Supplement 1

Grand Gulf Nuclear Station

Evacuation Time Estimate

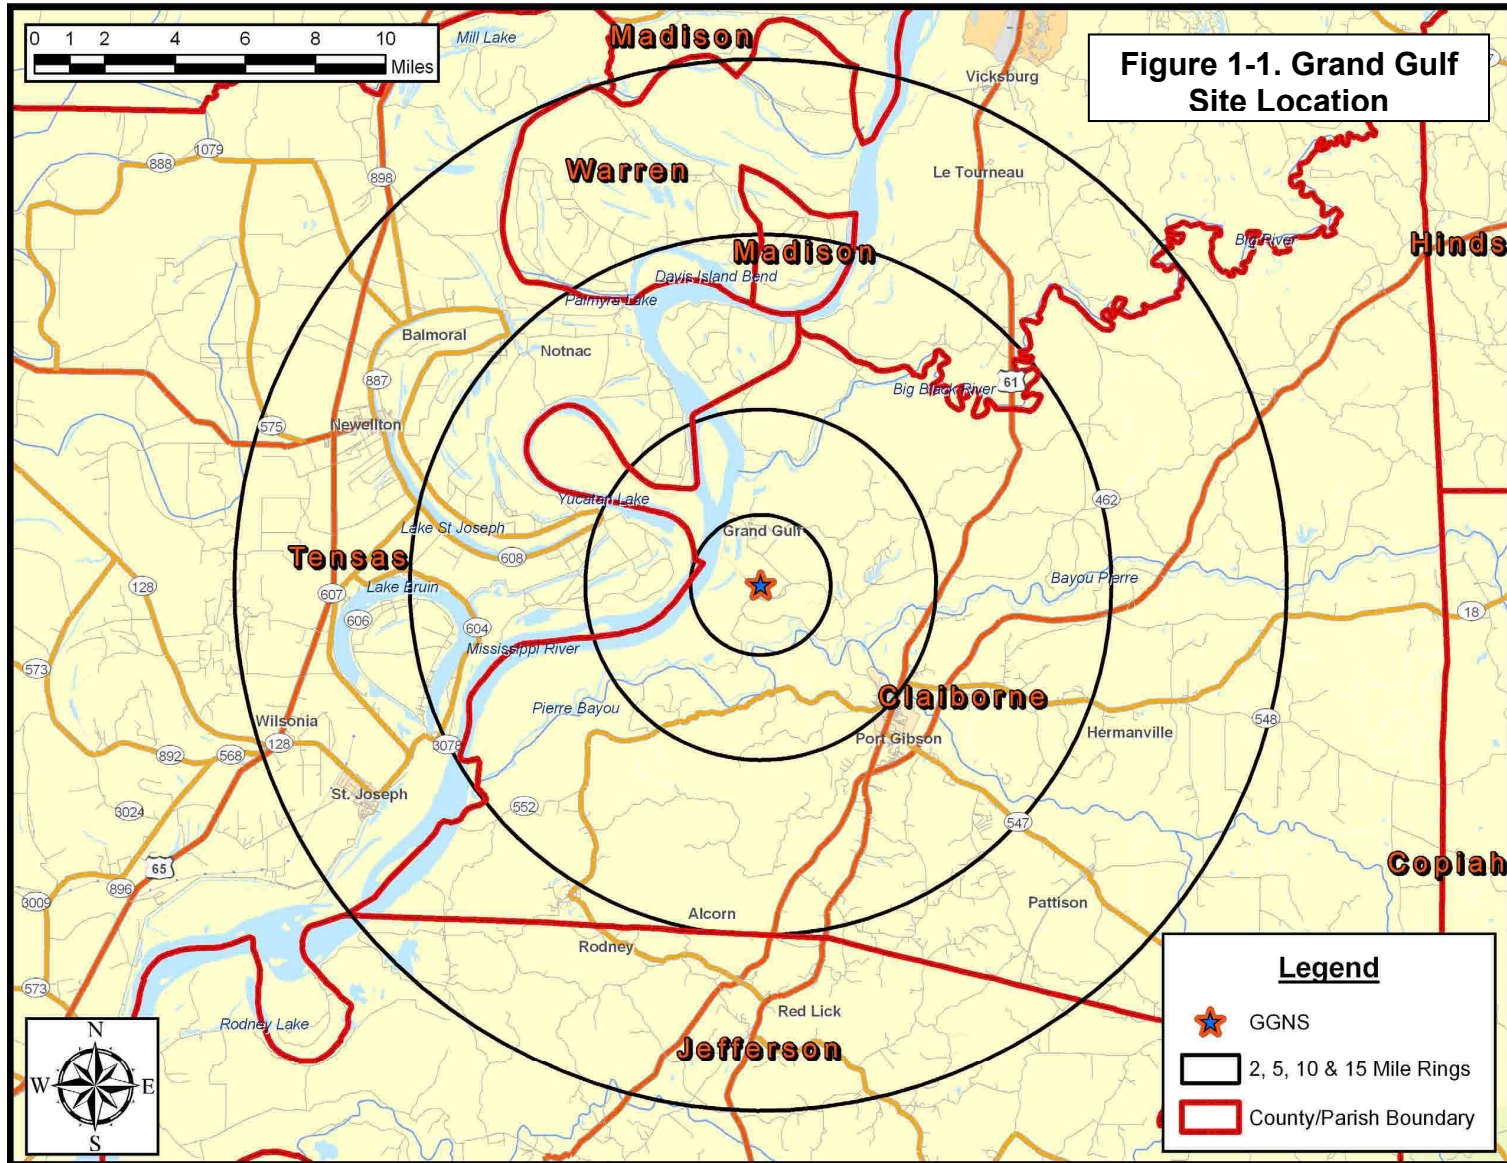
- Add labels to Figure 1-1 for communities, for major roadways and for bodies of water within the study area. See enclosed Figure 1-1.

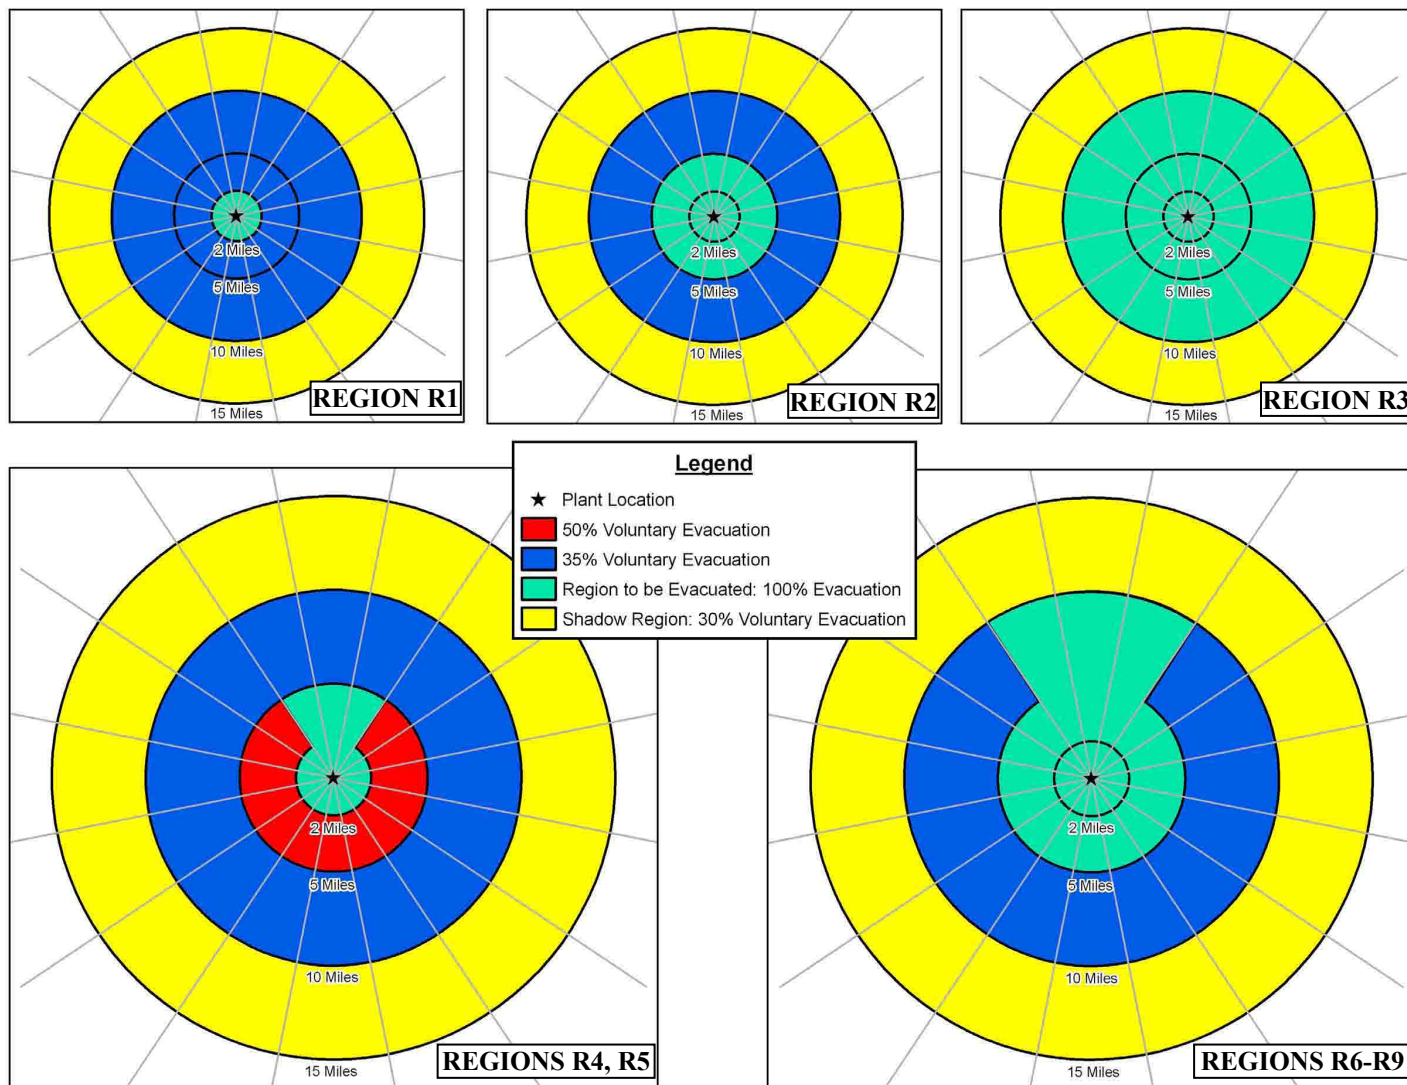
- Add labels to Figure 3-1 for major communities, for major roadways and for bodies of water within the study area. Also added county/parish boundaries and labeled the counties/parishes in the study area. See enclosed Figure 3-1.

**Figure 2-1. Assumed
Regional Evacuation**

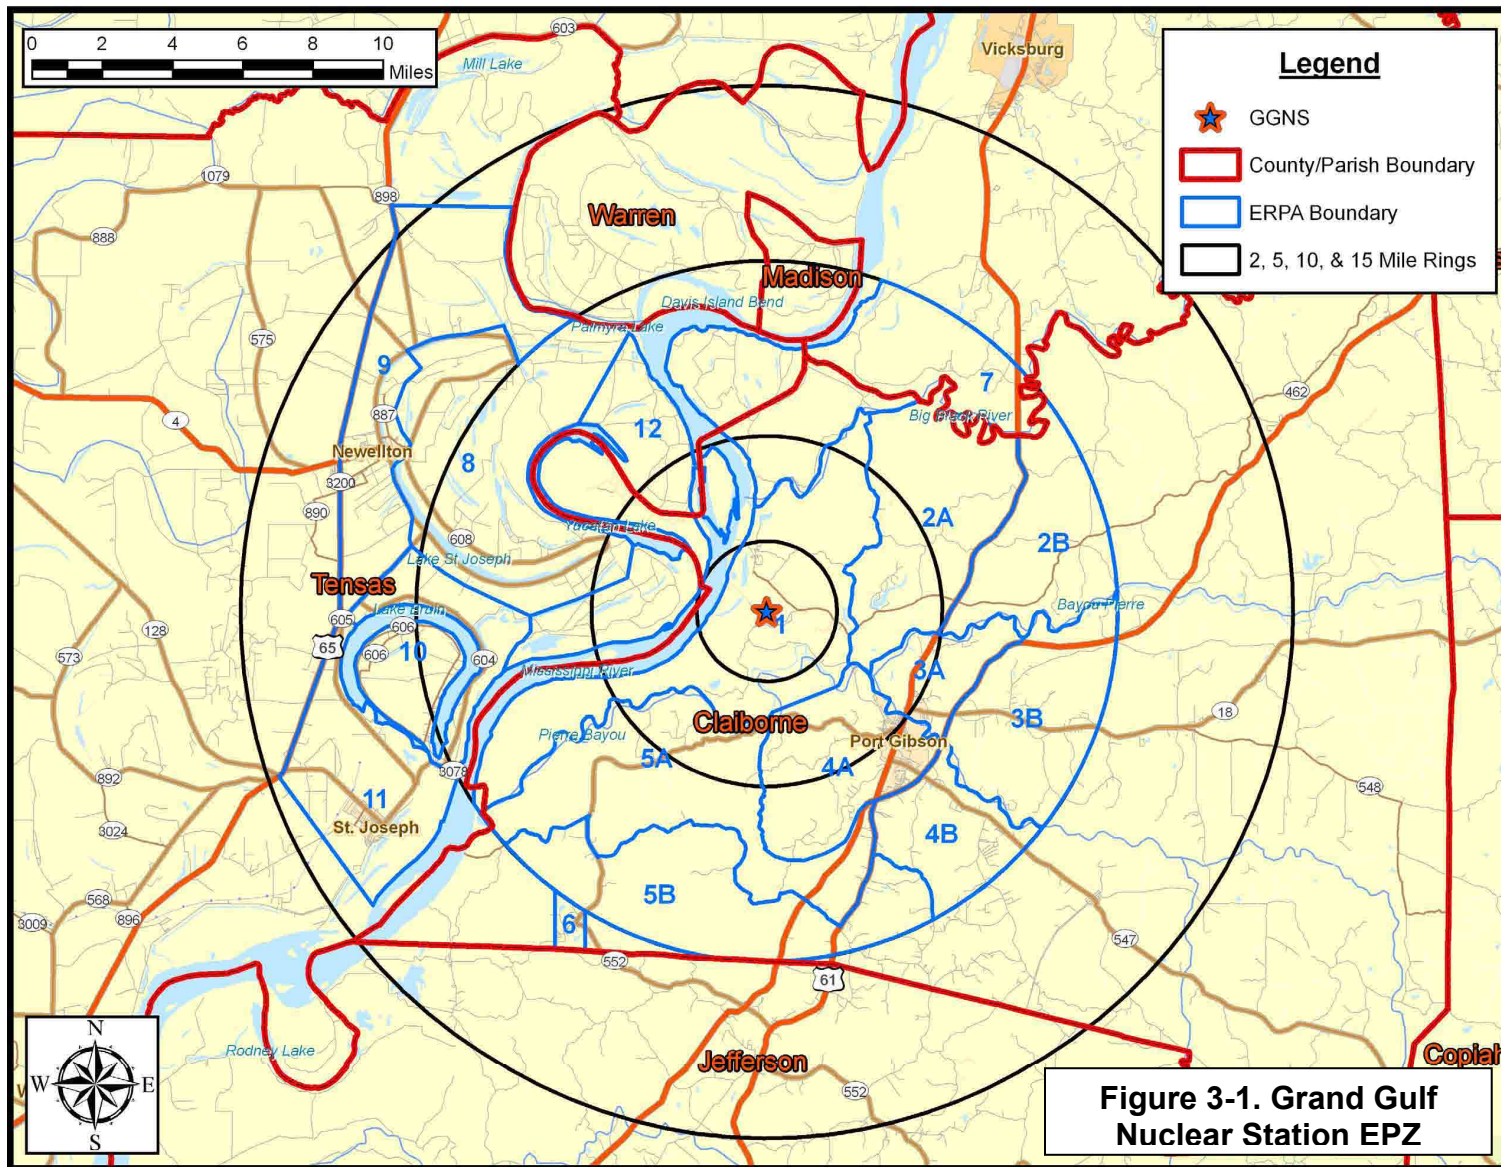
- Replace Figure 2-1. Changed title of Figure 2-1 to “Assumed Regional Evacuation Percentages”. See enclosed Figure 2-1.

Figure 5-1. Events and Activities Preceding the Evacuation Trip

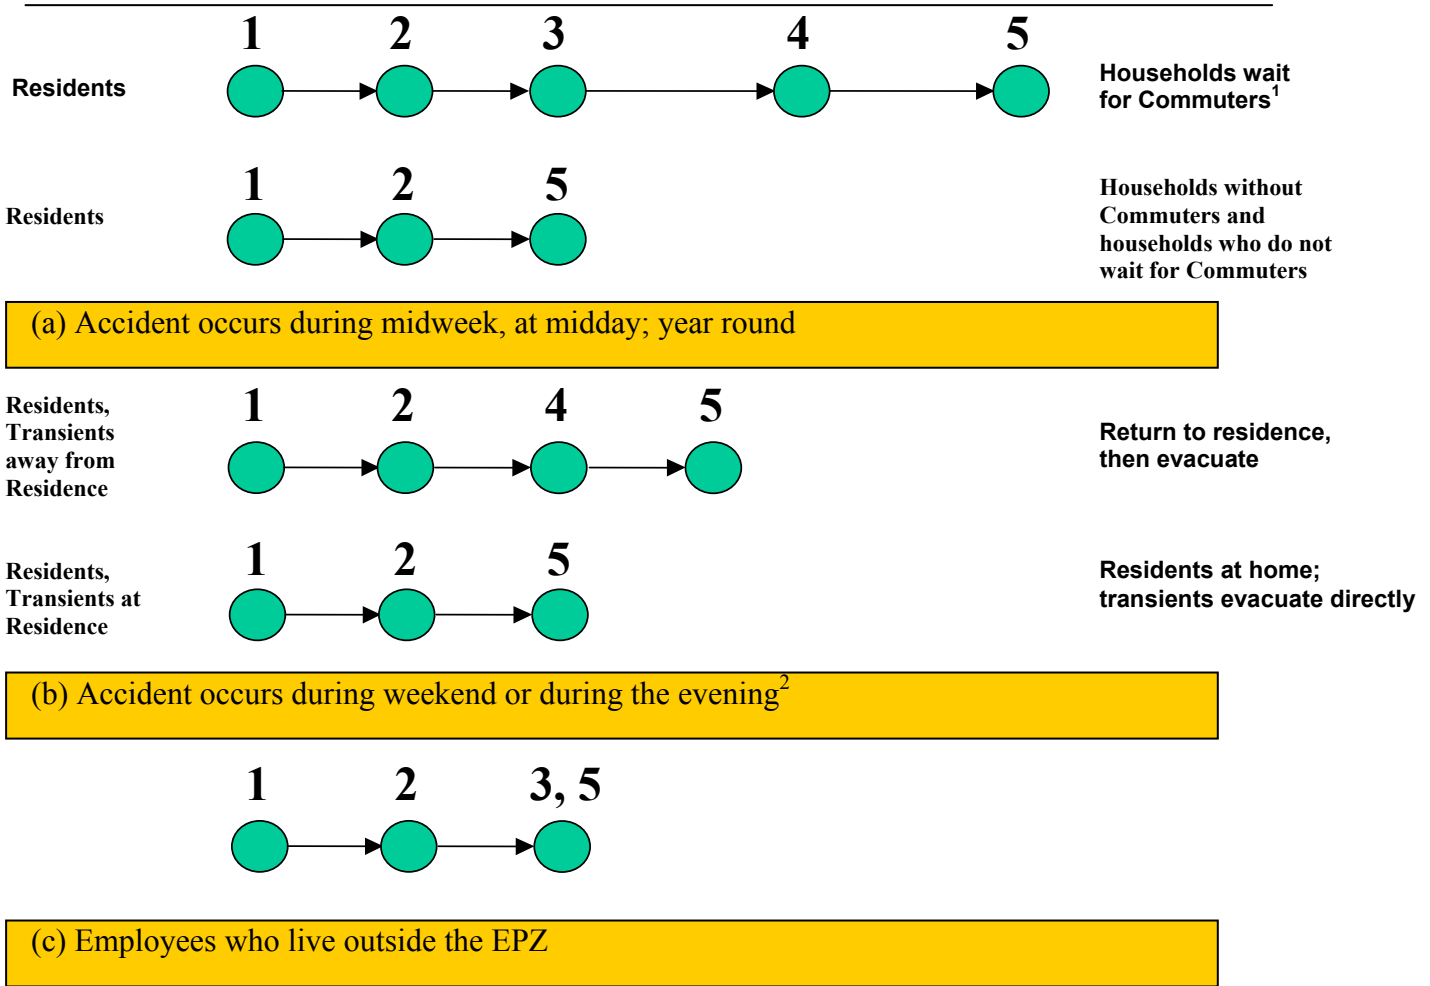
- Revise Figure 5-1 to agree with the text edits on pages 5-4 and 5-5. See enclosed Figure 5-1.

- Delete “to return home” from the Event Description for Event 3.
- Add two bullets to the bottom of the page. Bullet 1: “An Event is a ‘state’ that exists at a point in time (e.g., depart work, arrive home).” Bullet 2: “An Activity is a ‘process’ that takes place over some elapsed time (e.g., prepare to leave work, travel home).”
- Add a paragraph after the 2 bullets, reading: “As such, an Activity changes the ‘state’ of an individual (e.g. the activity, ‘travel home’ changes the state from ‘depart work’ to ‘arrive home’). Therefore, an Activity can be described as an ‘Event Sequence’; the elapsed times to perform an event sequence varies from one person to the next and are described as statistical distributions on the following pages.”

- Change “Prepare to leave for evacuation trip” to “Prepare to leave to evacuate” in the last row of Table 5-1.
- Replace the second paragraph with the following discussion: “An employee who lives outside the EPZ will follow sequence (c) of Figure 5-1. A household within the EPZ that has one or more commuters at work, and will await their return before beginning the evacuation trip will follow the first sequence of Figure 5-1(a). A household within the EPZ that has no commuters at work, or that will not await the return of any commuters, will follow the second sequence of Figure 5-1(a), regardless of day of week or time of day. Note that event 5, “Leave to evacuate the area,” is conditional either on event 2 or on event 4. For this study, we adopt the conservative posture that all activities will occur in sequence.”

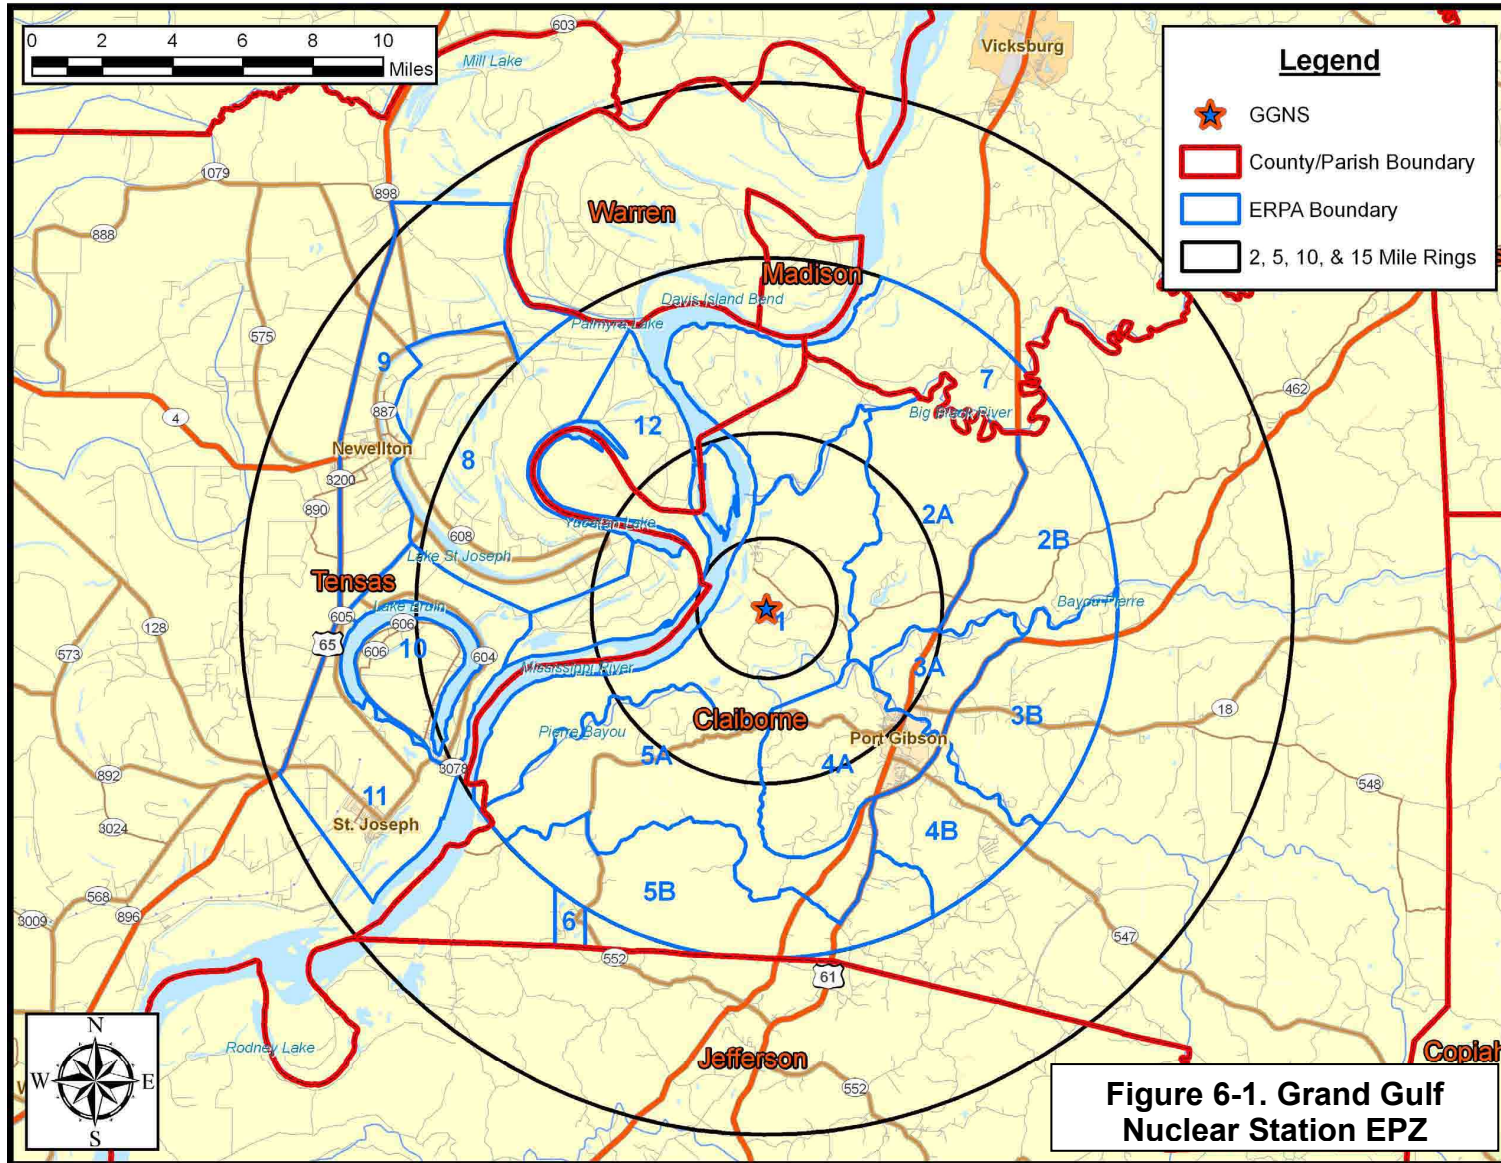
- Add labels to Figure 6-1 for major communities, for major roadways and for bodies of water within the study area. Also added county/parish boundaries and labeled the counties/parishes in the study area. See enclosed Figure 6-1.

**Figure 7-1. Assumed
Regional Evacuation**

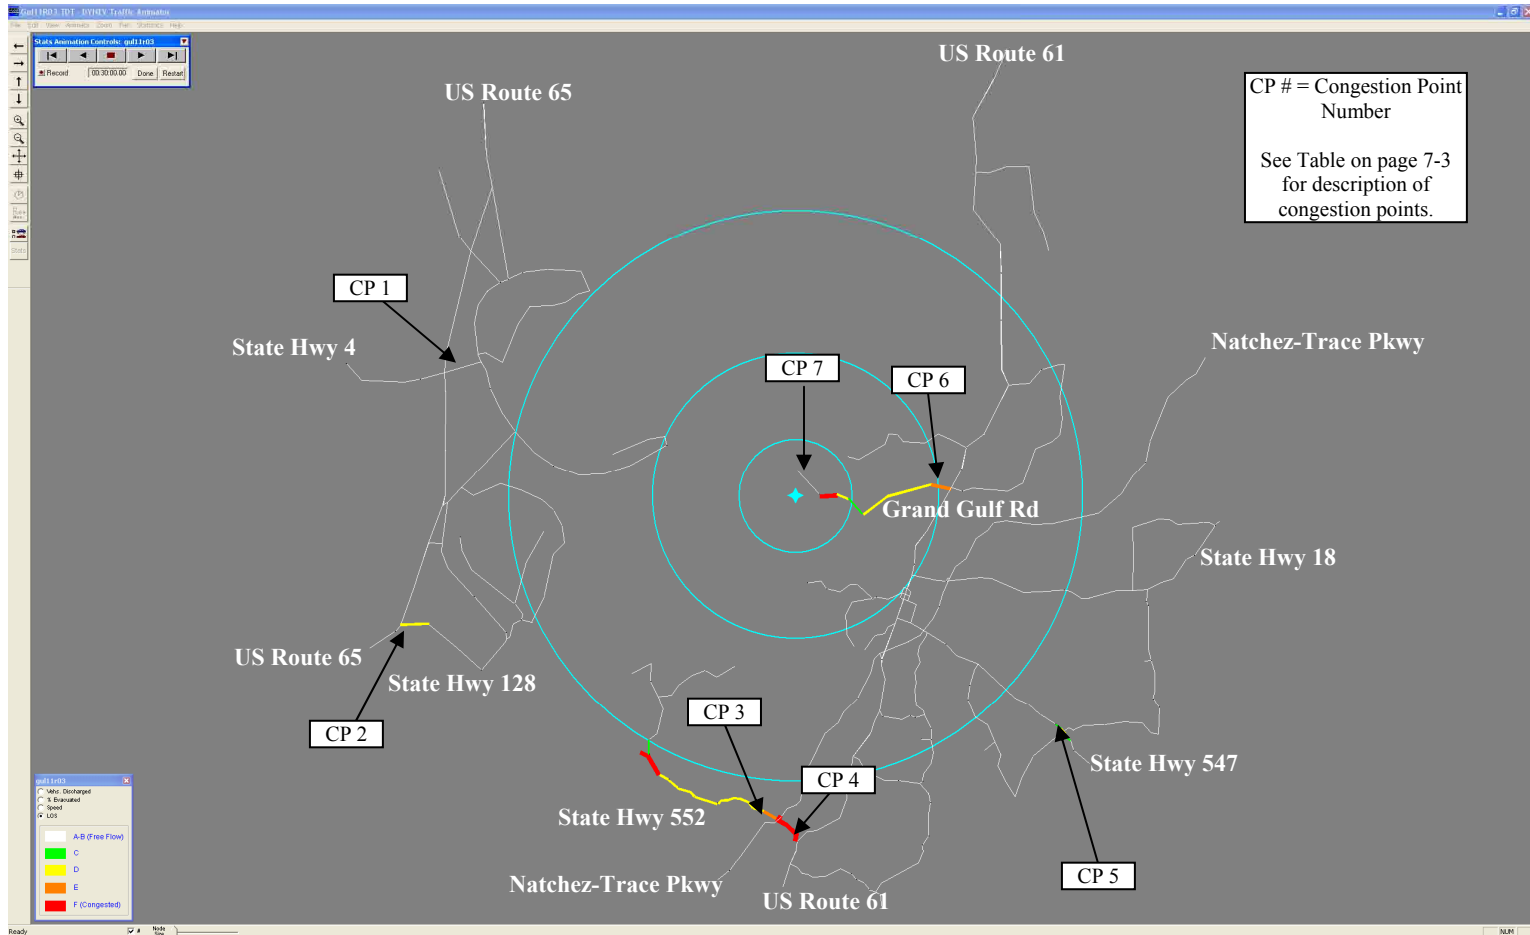
- Replace Figure 7-1. Change title of Figure 7-1 to “Assumed Regional Evacuation Percentages”. See enclosed Figure 7-1.
